LIFT STATIONS REHABILITATION - PHASE 5
Solicitation Number: CO-00431
Job No.: 16-2502

ADDENDUM 2

June 4, 2021

STRUCTURAL NOTES

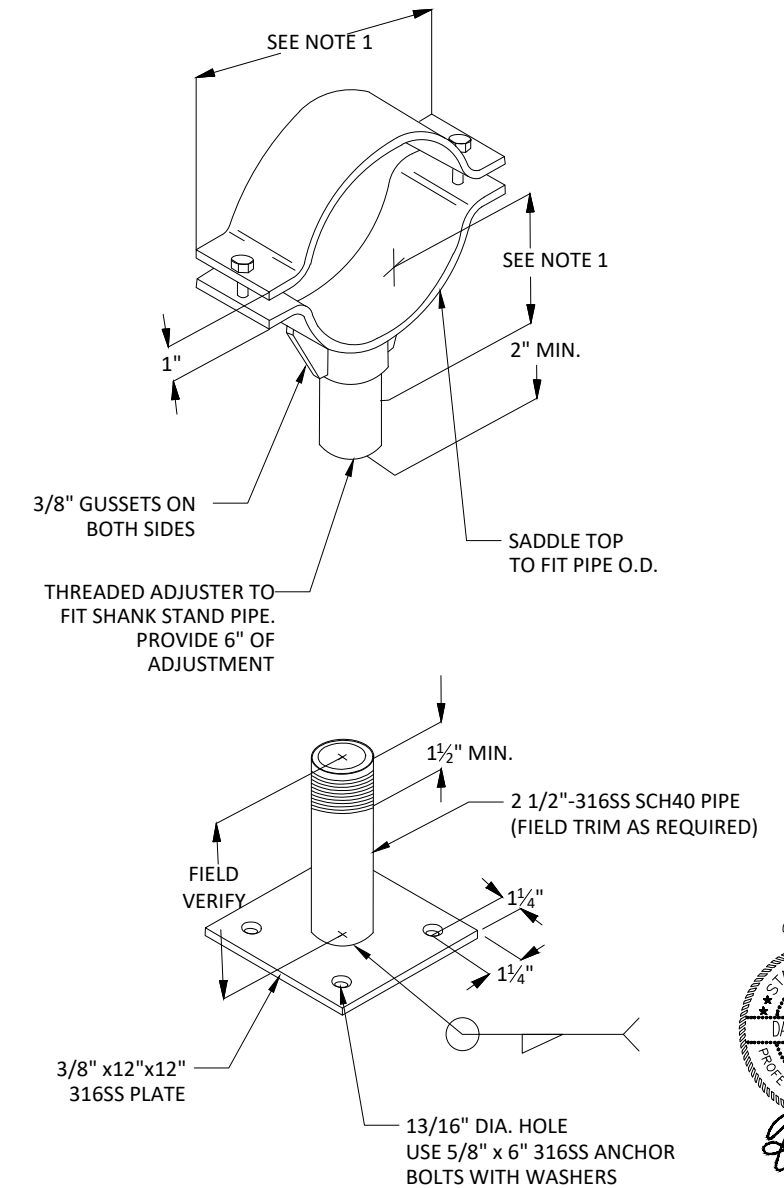
1. Sheet S-1 (110 of 150) REMOVE and REPLACE in its entirety.
 - a. S-1 Structural Notes

No.	Revision	Drawn	Approved	Date
1	DELETED H-20 WHEEL LOAD NOTE	IG	DP	5-12-21
